Minor Arm Geometry

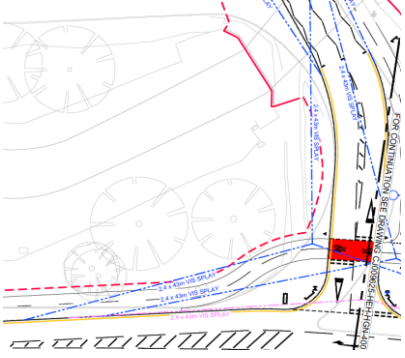
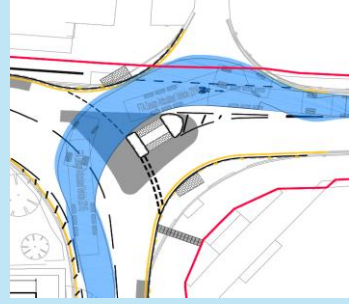
The Highway Authority further notes that some background model results in Appendix materials flag up data warnings, particularly in relation to PICADY parameters (zero flare lengths and HGV percentages) and visibility assumptions.

These issues were previously raised in the pre-application response and should have been addressed in the updated modelling submission. Whilst this is not an issue that would necessarily lead to any formal objection, this is a valid technical concern as it highlights areas where the modelling lacks clarity or robustness and where the **applicant should be expected to provide clarification or updated inputs to support the conclusions.**

The warnings flagged by the software were noted and judgement was exercised in reviewing outputs considering the warnings. It should be noted that they are warnings and not errors so the modelling still produced a valid output.

In the PICADY model the flare length was inputted as per the geometric measurements taken from the GA design at the time (see extract). The warning generated from PICADY highlights that the flare length is close to 0 PCUs. By default, PICADY has increased this to 1 PCU as a minimum value. Any increase in the flare length above the minimum length would improve the capacity of the

The HGVs in PICADY are included as the flows are PCU data and not just vehicle counts. It is recognised that the warning message says to include HV% even if PCUs are used. I have looked back at my OD calculations and note that just 1 HGV was counted exiting Waterloo Court (this was during the AM peak and is a left turner). I therefore believe using a zero HV% is correct for PM and Saturday scenarios. The presence of 1 HGV in the AM peak is of little consequence since the total count was only 20 vehicles. The unsignalised Level of Service for Waterloo Court arm is Level A in 2040 conditions which indicates no delay to vehicles turning out of the junction.

Visibilities were measured from the GA design at the time of modelling. The visibility from the junction remains good, therefore no update to visibility is required.
